STAFF REPORT
4,200 SF ADDITION TO VEHICLE SERVICE CENTER
COTTAGE GROVE CHEVROLET
SITE DESIGN REVIEW SDR 1-22
MARCH 16, 2022

Comments were received from Ron Bradsby, City of Cottage Grove Engineer on March 2, 2022. The comments are addressed in this staff report and included in the conditions of approval.

To: Eric Mongan, City Planner

COTTAGE GROVE CHEVROLET SERVICE BAY ADDITION

SHEET TITLE:
**SITE GRADE
 DRAINAGE PLAN**

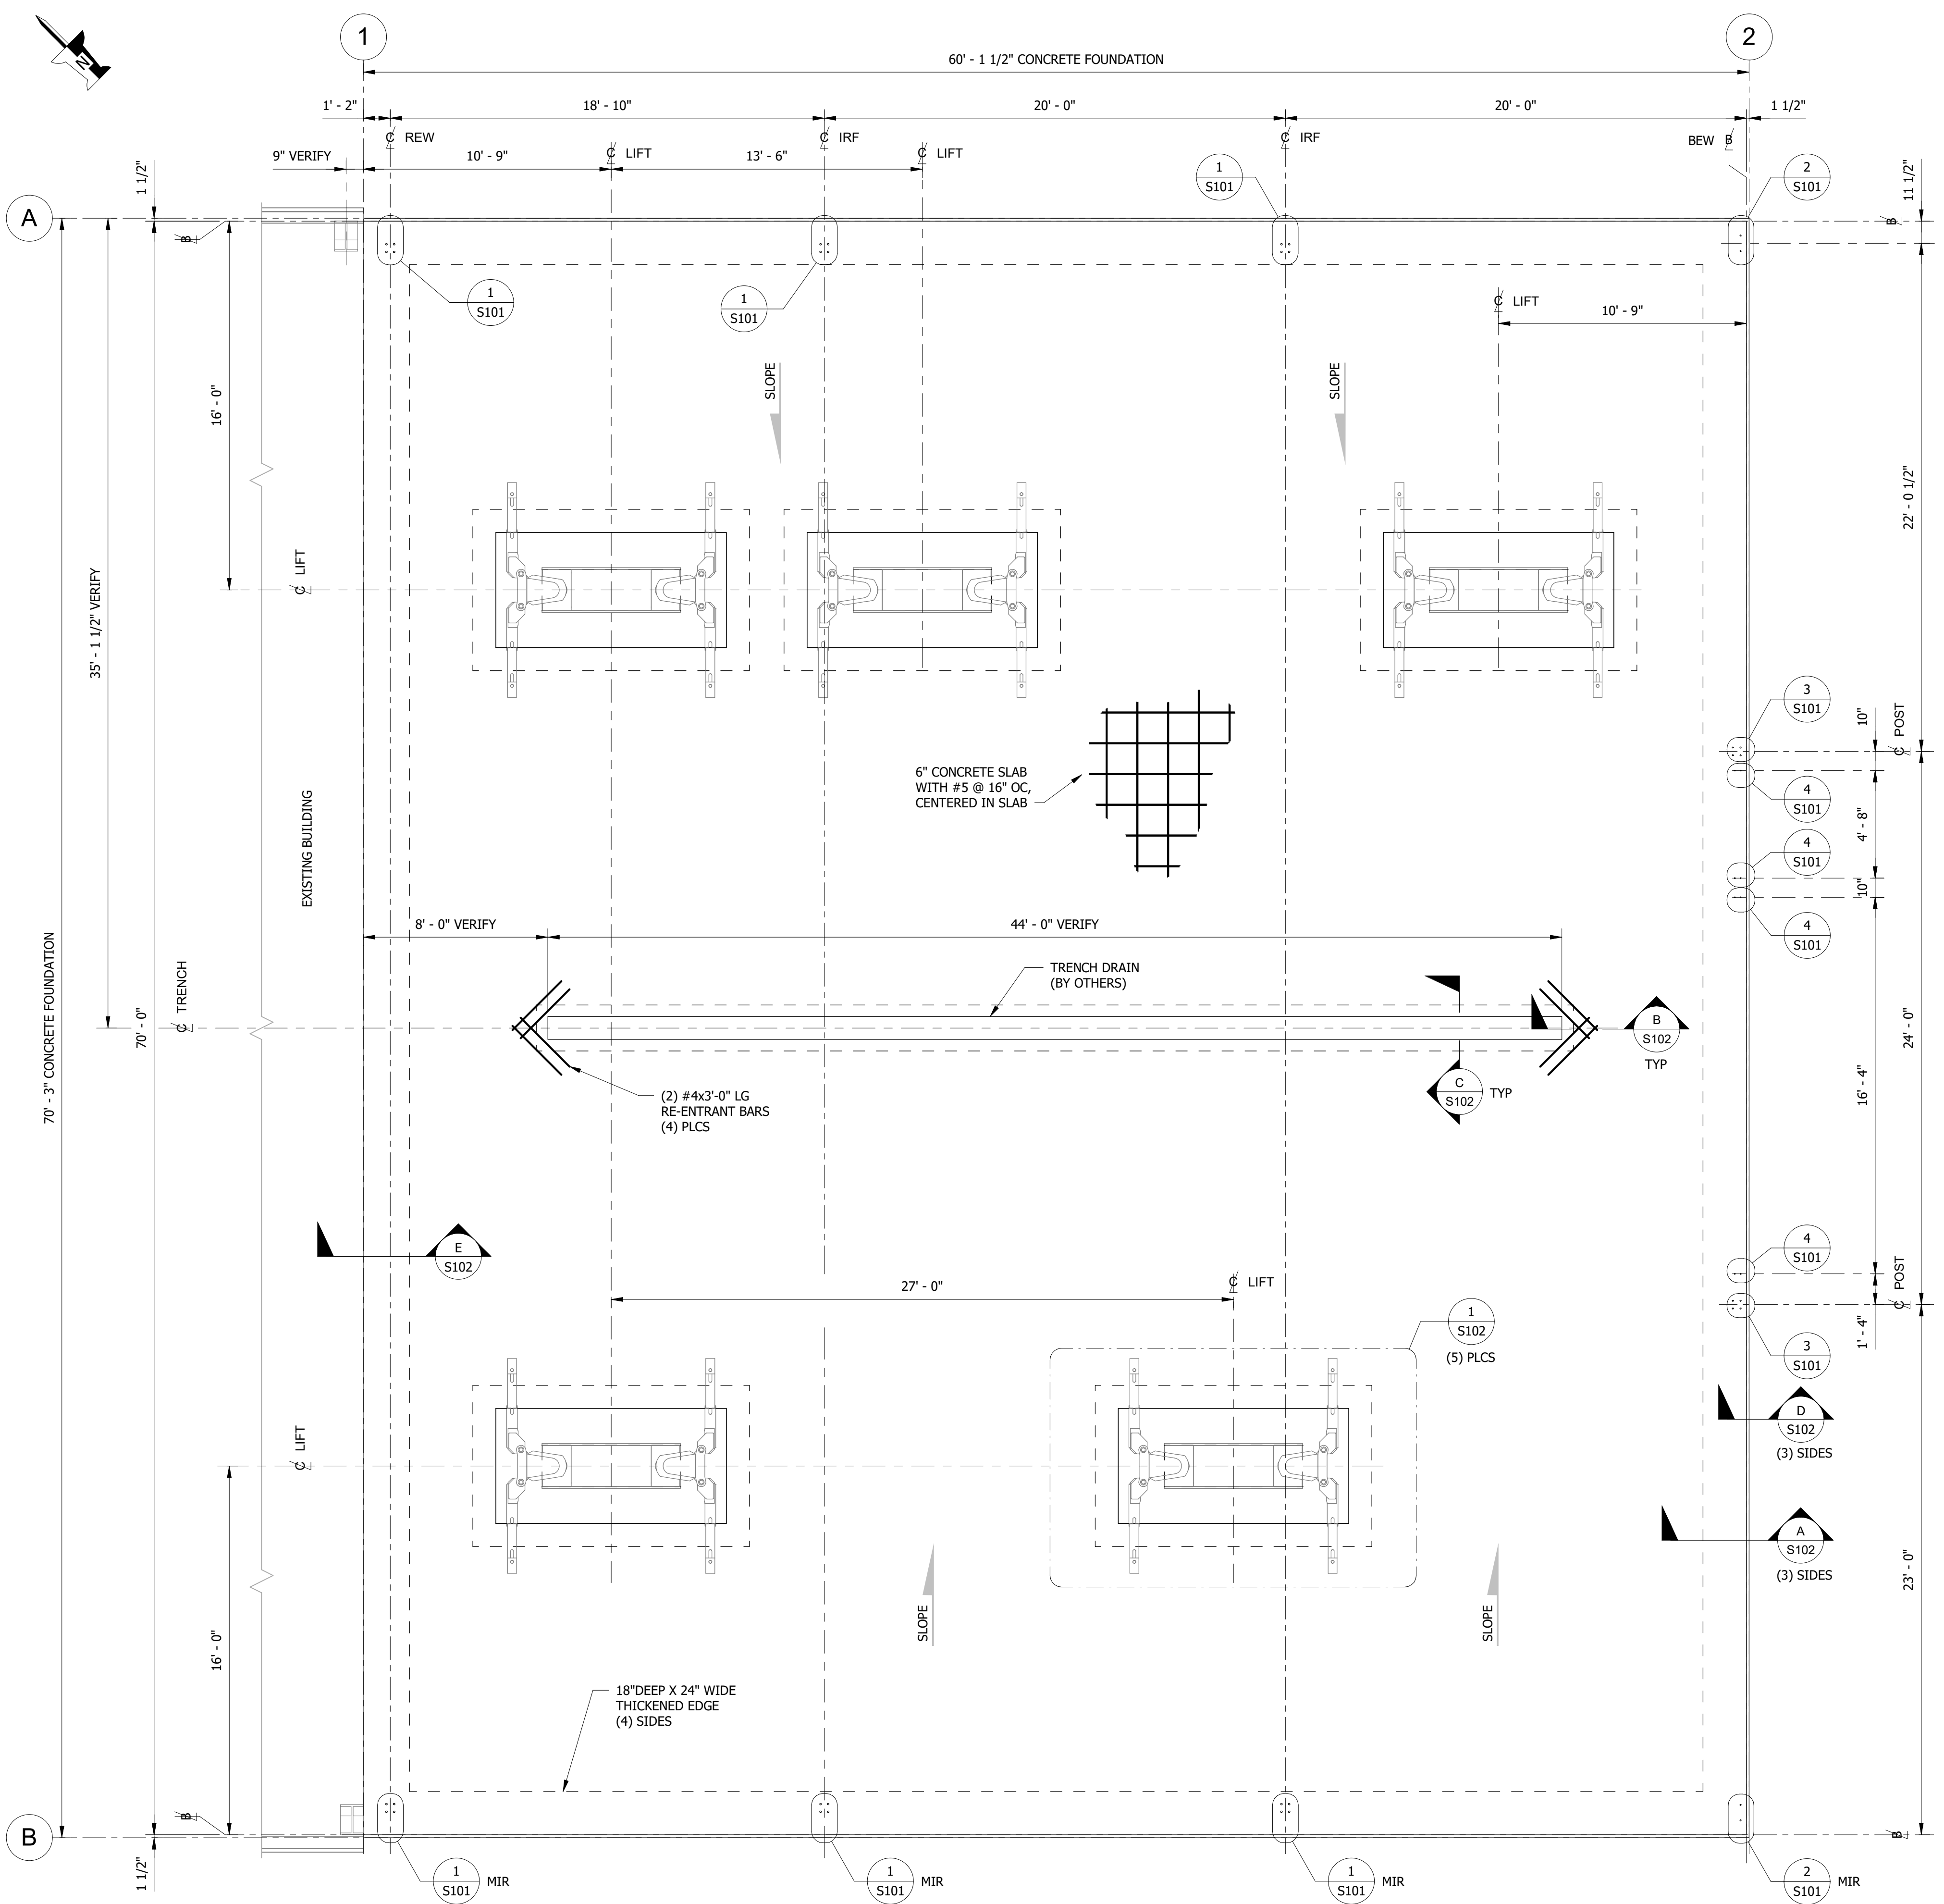
- Sheet A100 near the Building Code Summary and Design Build Notes, there is some overlapping text. On the building permit plans, it would be nice if this was corrected.
- Sheet A105 – The model number on the separator note does not match the model number in the detail. Please correct.

- An 8-inch sanitary sewer serves the property currently off Mosby Creek Road.
- Effluent from the Oil/Water Separator needs to drain to the sanitary sewer.
- Is the trench drain and collector box inside the new addition connected to the oil/water separator? I did not see any connection between the two in the plans.
- I am having difficulty understanding how the oil in the water is going to gathered. From the detail from Gibson Steel, it appears that outlet of the structure is below the level of the absorbent pouches. The proposed structure is great for removing sediment. Designer should verify that this particular structure should be used in this situation.

- From the detail on Sheet 105, half of the separator structure has a grate on it. From the location shown on the plans, this is not acceptable. Storm water cannot get into the structure and go to the sanitary sewer. The City of Cottage Grove has separated the storm water and sanitary sewer infrastructures and is actively separating any cross connections. .
- Storm water runoff is not to adversely affect adjacent property owners; therefore no overland flow is allowed. All storm water runoff from this development shall be contained on the property prior to connecting the public storm drainage system.
